# Service-Information

Group 11 Engine	May 1983	Bulletin No.: 11 024 83 (2077)
--------------------	-------------	-----------------------------------

RE: INSTALLATION OF THE OIL FILTER HOUSING CANISTER

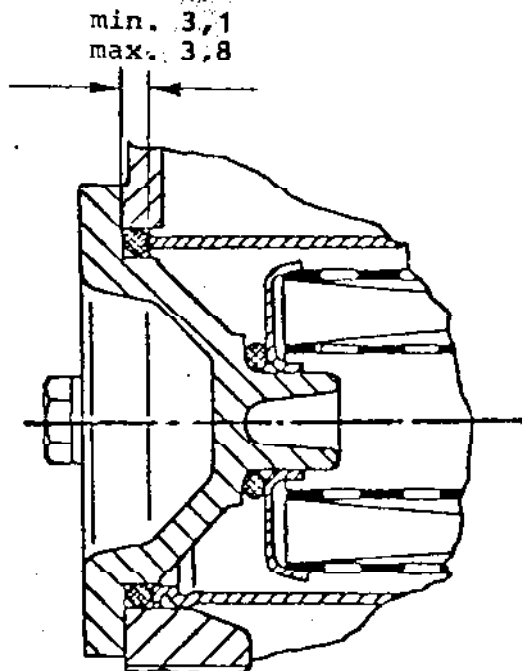
With the introduction of the R65 and change in the oil passages on all motorcycles beginning in 1980, it is possible in isolated cases that a small oil pressure drop can occur.

We suggest that during any service or rebuilds, the depth of the oil filter canister sleeve to crankcase cover be measured.

The distance between the oil filter cover surface and the face of the oil filter canister sleeve should be as referenced in the line drawing. Excessive clearance will cause a poor seal between the cover and canister sleeve and oil pressure will be reduced or fail.
